ADDENDUM NO. 1

<u>CROSS OAK DRIVE, FORTUNATE PLACE, REDAN DRIVE AND</u> <u>SILICON PRAIRIE PARKWAY ASSESSMENT DISTRICT - 2014</u>

CONTRACT NO. 7224

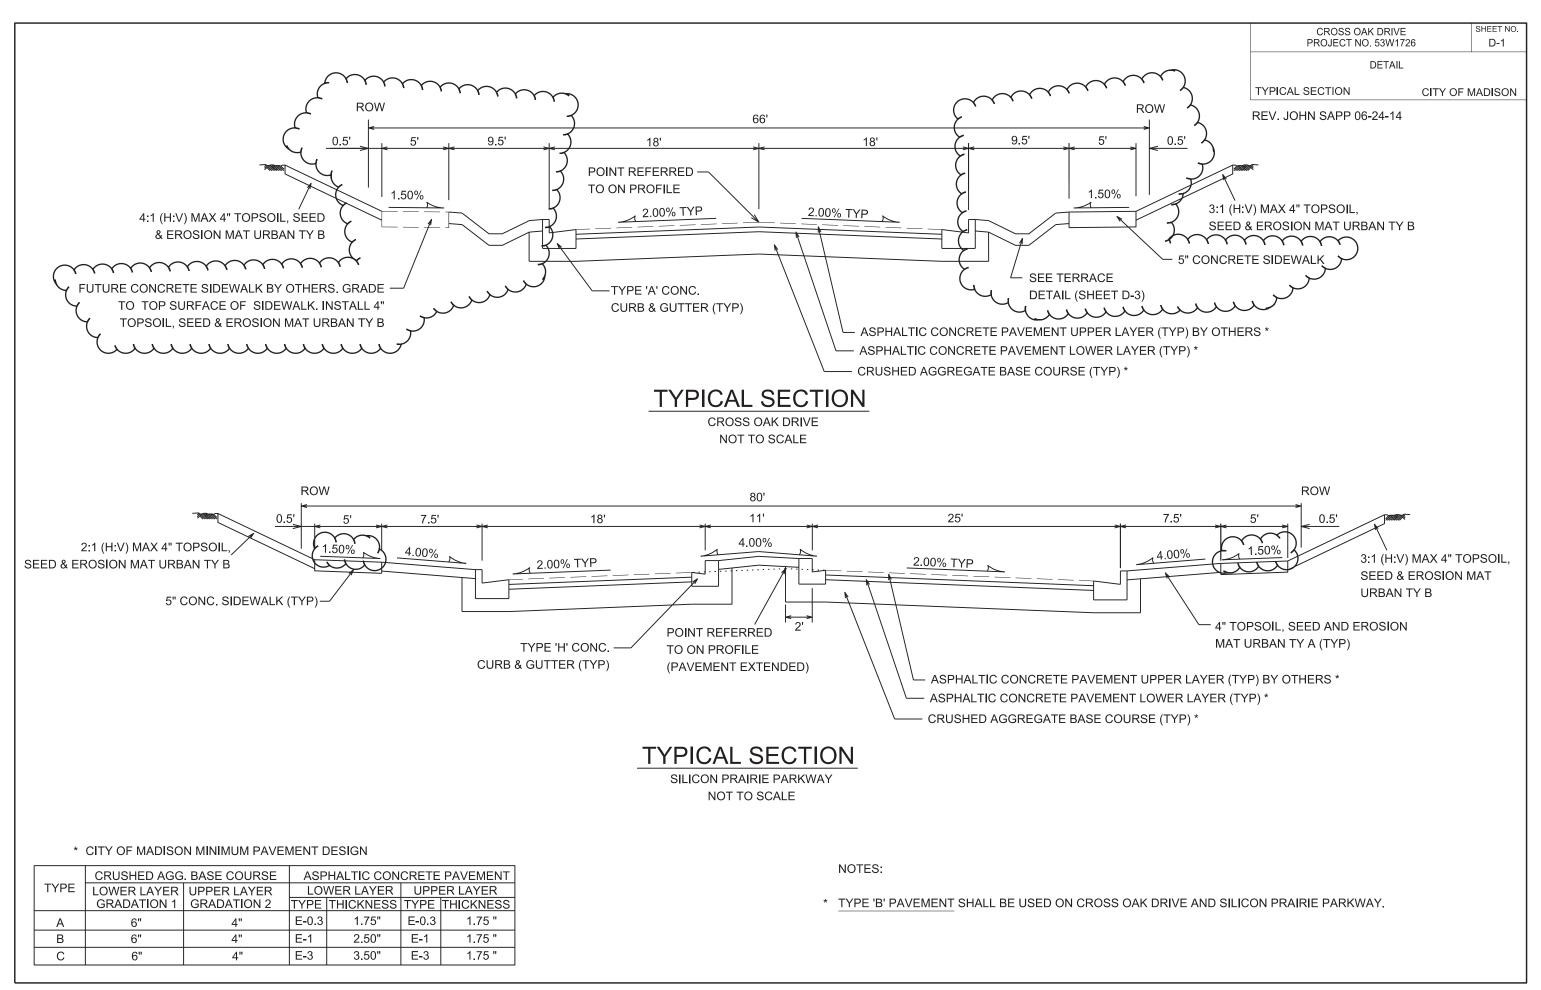
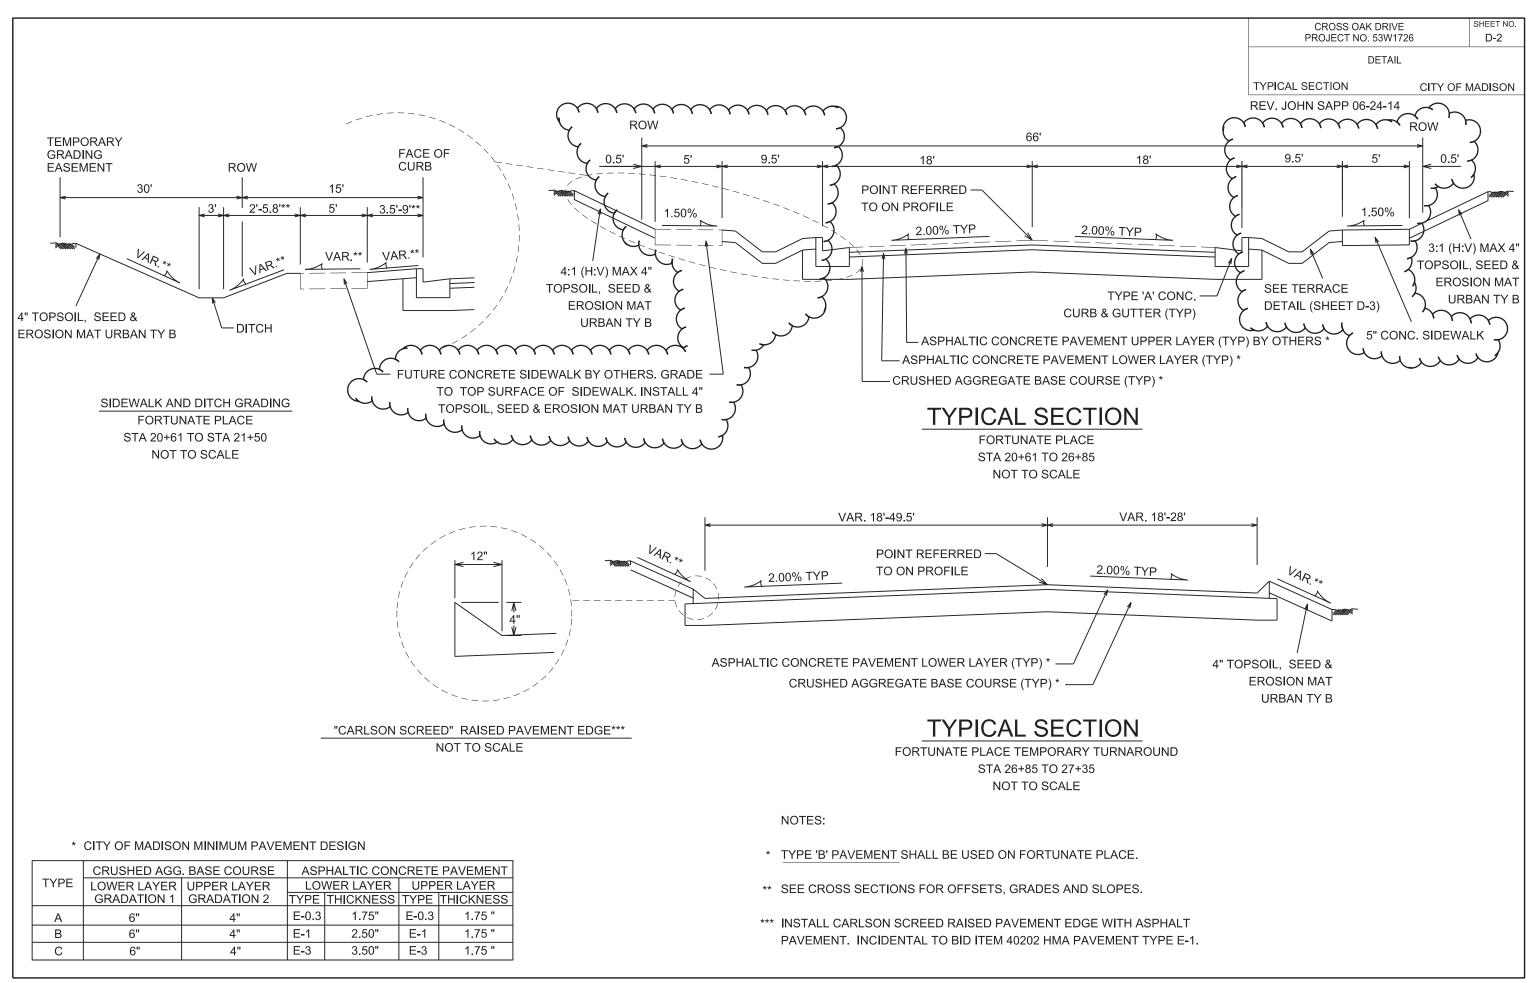
D1-D3: Typical sections and details revised to eliminate pervious concrete sidewalk and to install an infiltration swale within the terrace on the right side of Cross Oak Dr., Fortunate Pl., and Redan Dr. Earthwork quantities and notes also revised on sheet D3.

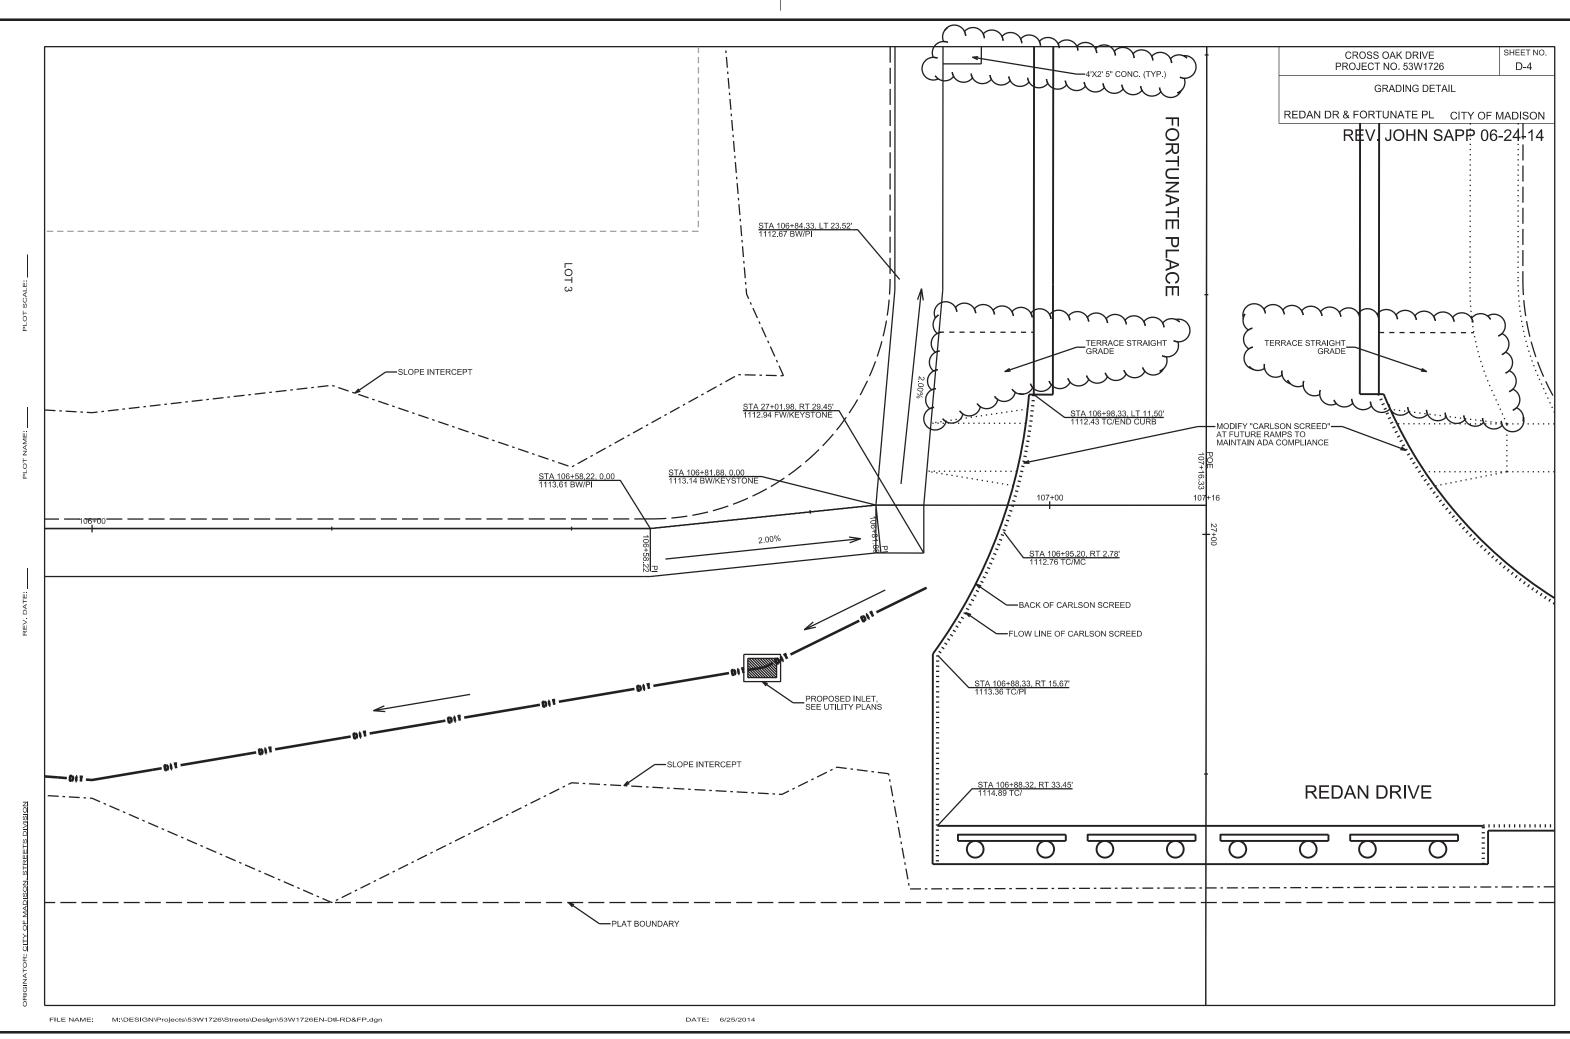
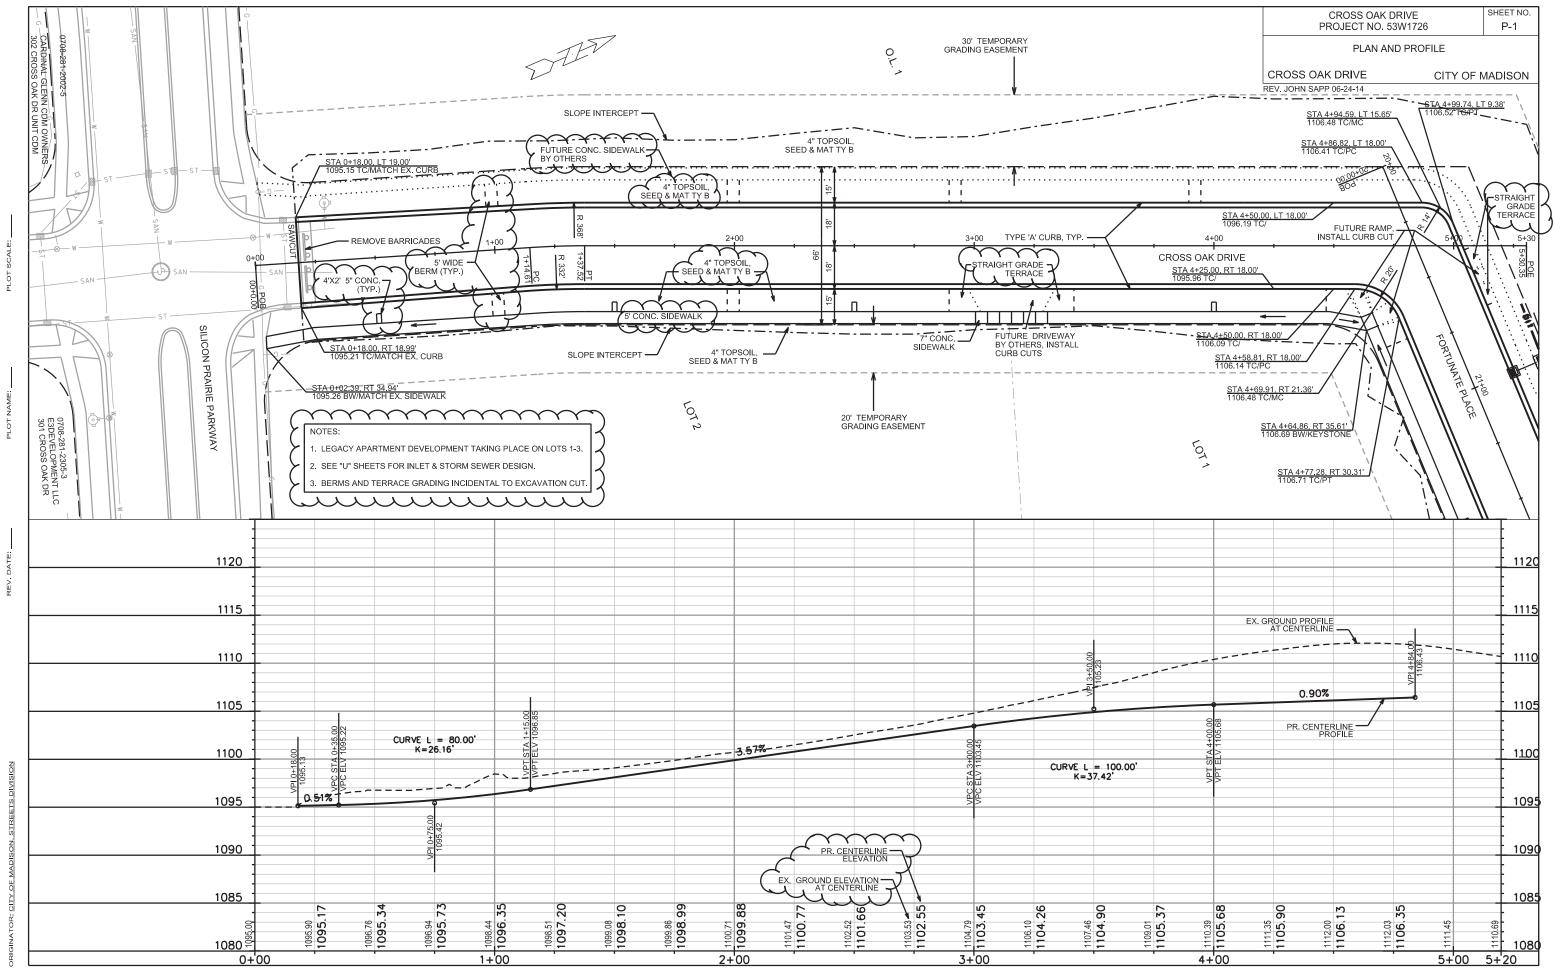
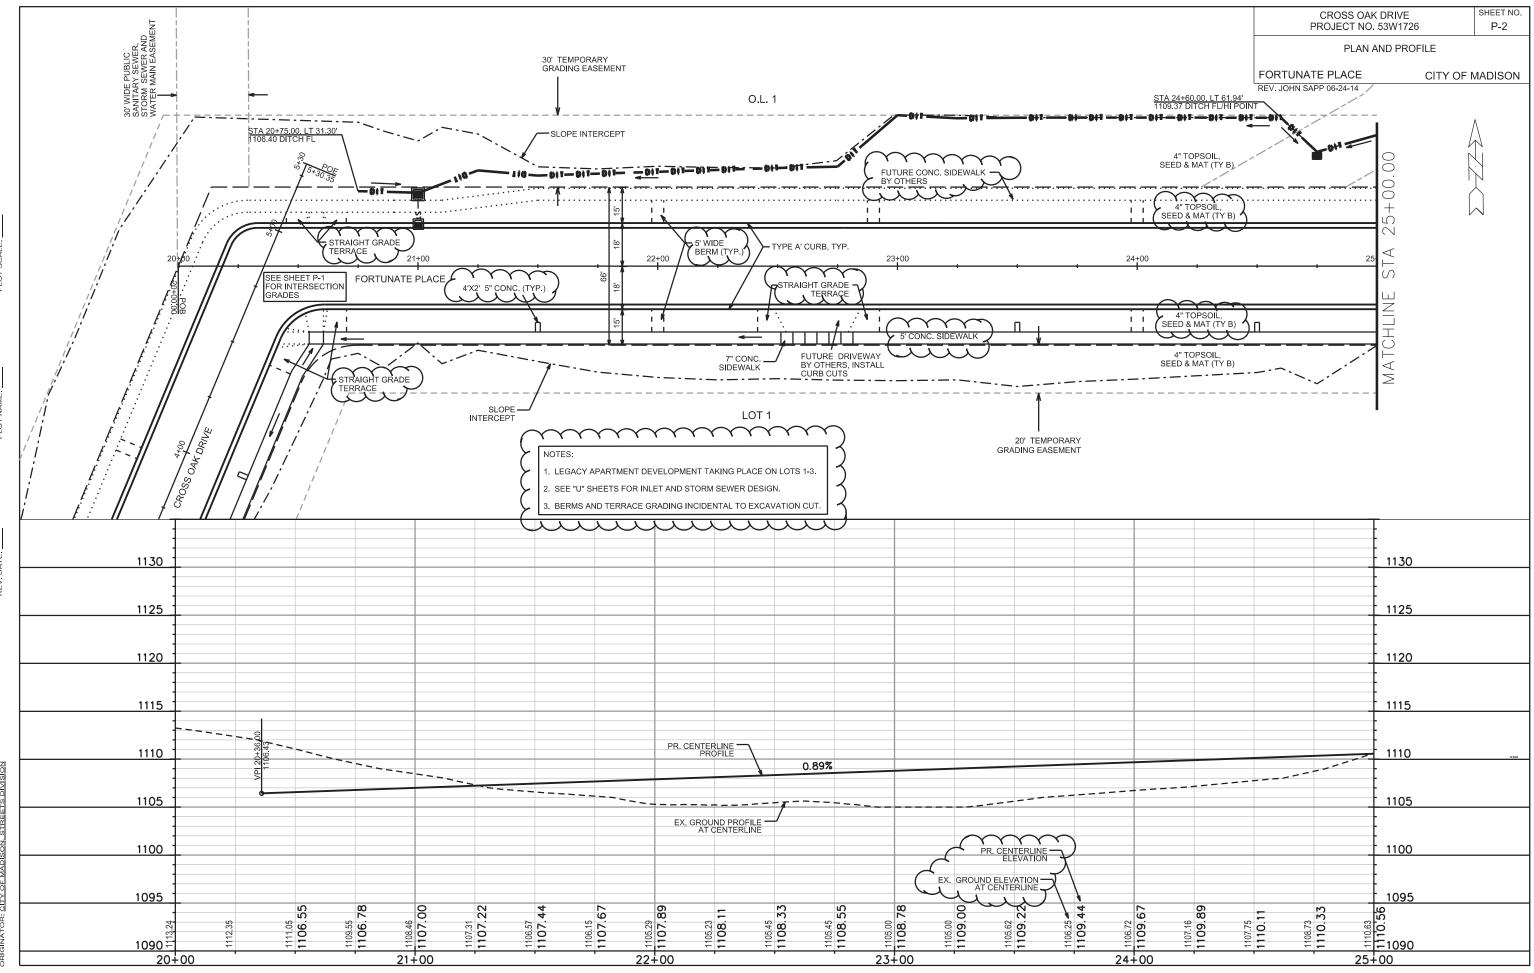
P1-P3 & P5: Plan and Profile sheets revised to remove pervious concrete sidewalk from Cross Oak Dr., Fortunate Pl. and Redan Dr. and to install swale within the terrace adjacent to the development with concrete sidewalk stubs and earthen berms. Areas of different types of erosion mats were also revised.
